**Classification criteria and related hazard communication:
review of Chapter 2.1**

Review of Chapter 2.1 – amended and commented criteria flowcharts after ICG-meetings in November/December 2018

Transmitted by the expert from Sweden

Criteria-flowchart for the scope of the hazard class Explosives, as amended/commented by the EWG on 29 November 2018

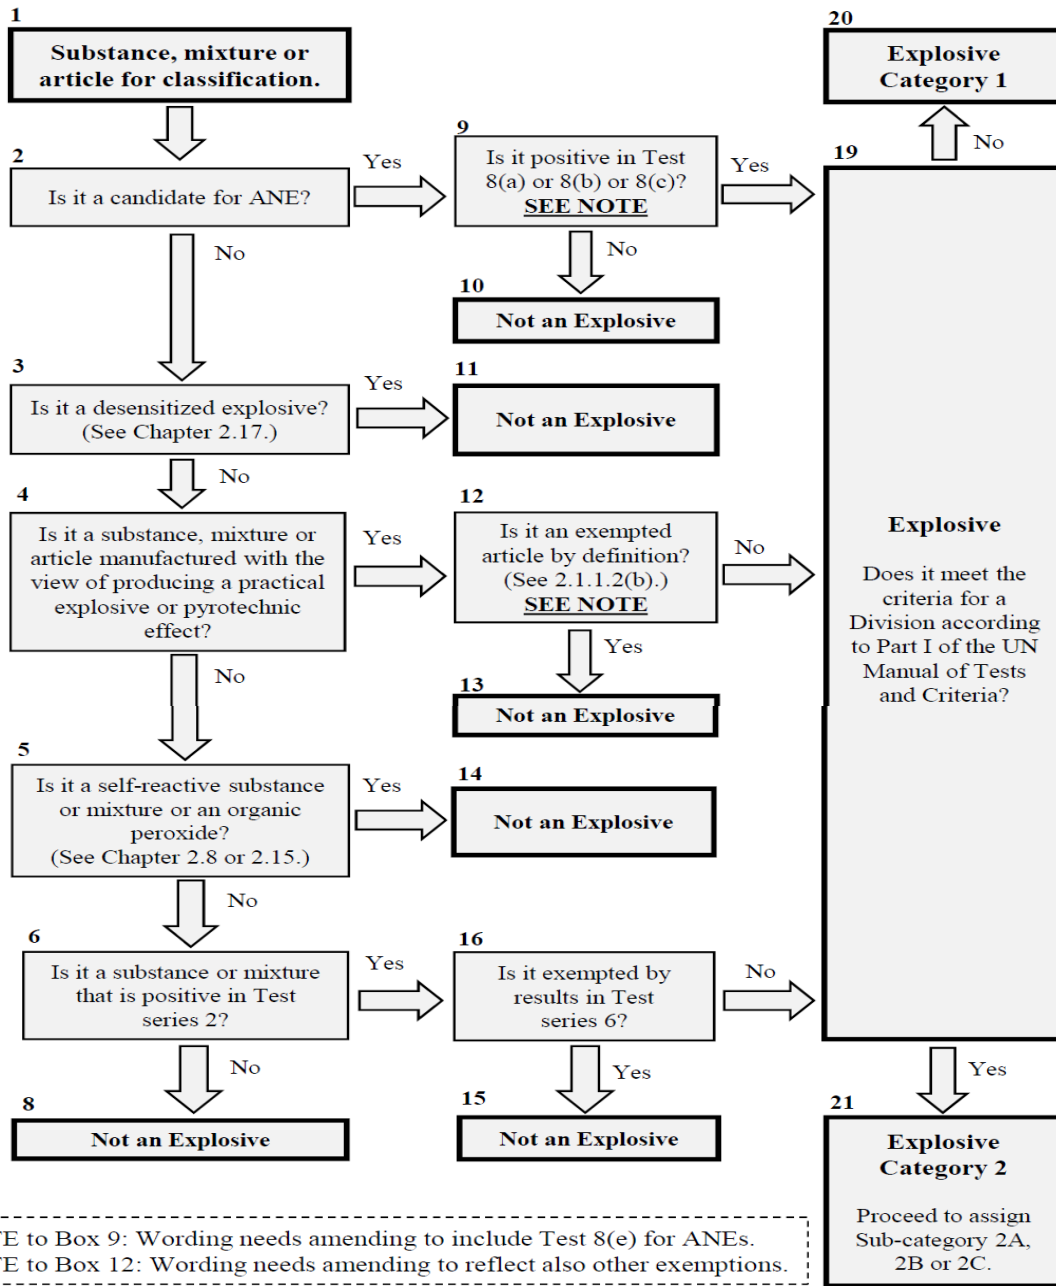
1. At the joint meeting of the Informal Correspondence Group on the review of Chapter 2.1 (ICG) and the Working Group on Explosive (EWG) on 29 November 2018, the flowcharts of Annex 1 in WD20 (SCEGHS)/85 (SCETDG) and Annex 1 of INF.10 (SCEGHS)/INF.13 (SCETDG) were slightly amended and commented. These amendments and comments are reflected in paragraph 10 of the report from the EWG in INF.50 to the SCETDG (and reproduced in INF.34 of the SCEGHS).

Criteria-flowchart for Sub-categories 2A-C within Category 2 for Explosives, as amended/commented by the EWG on 29 November 2018

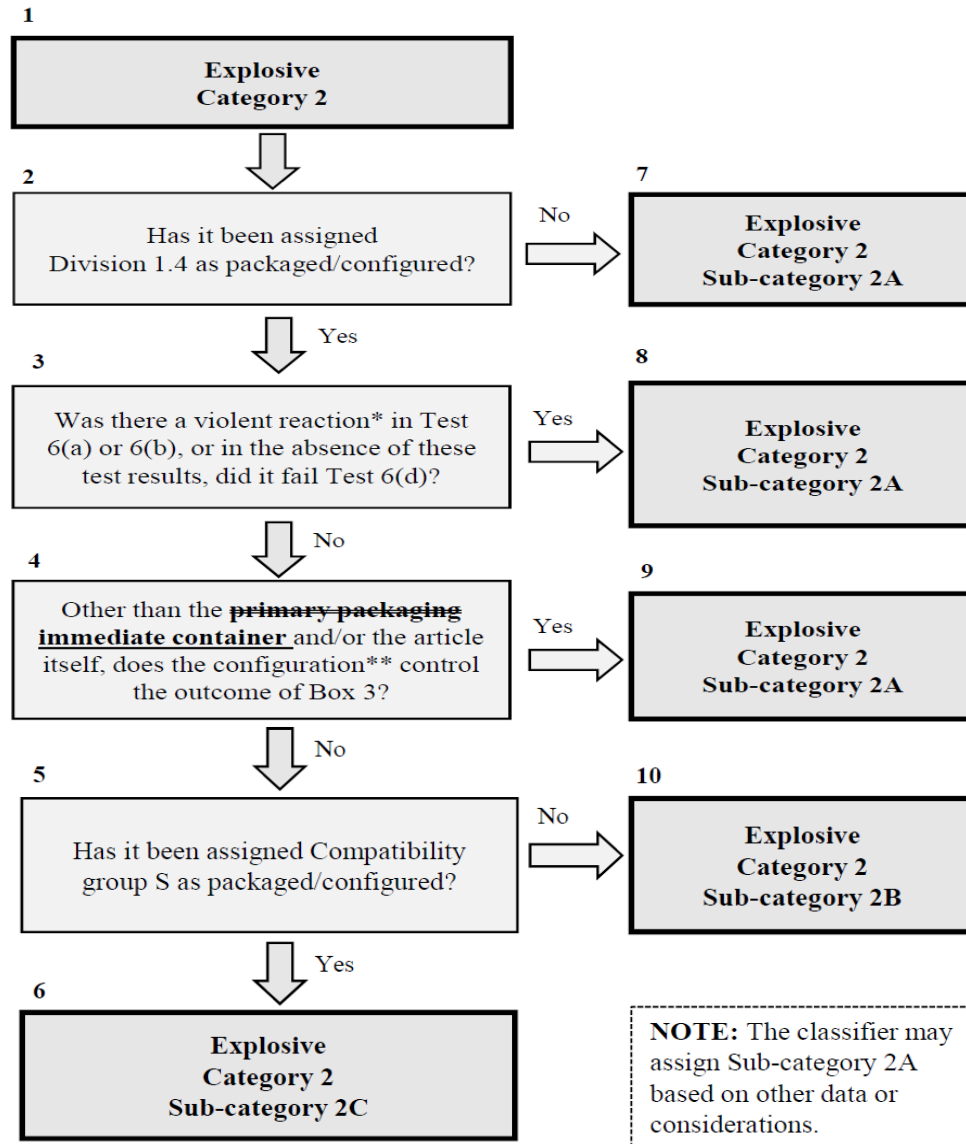
2. The slightly revised flowcharts formed the basis for the ICG-meeting on 5 December 2018 and were shown to the SCEGHS in plenary when the expert from Sweden reported back from that meeting on 6 December 2018. To facilitate future discussion, these flowcharts are reproduced as Annex 1 and 2 to this document, respectively. The notes in Box 9 and 12 in the flowchart of Annex 1 serve as a reminder and are not to be included in the boxes. Box 7, 17 and 18 of this flowchart are missing as they have been removed. In the flowchart of Annex 2, “primary packaging” has been replaced by “immediate container” in Box 4. See INF.34 (SCEGHS) or INF.50 (SCETDG) for detailed explanations on these amendments.
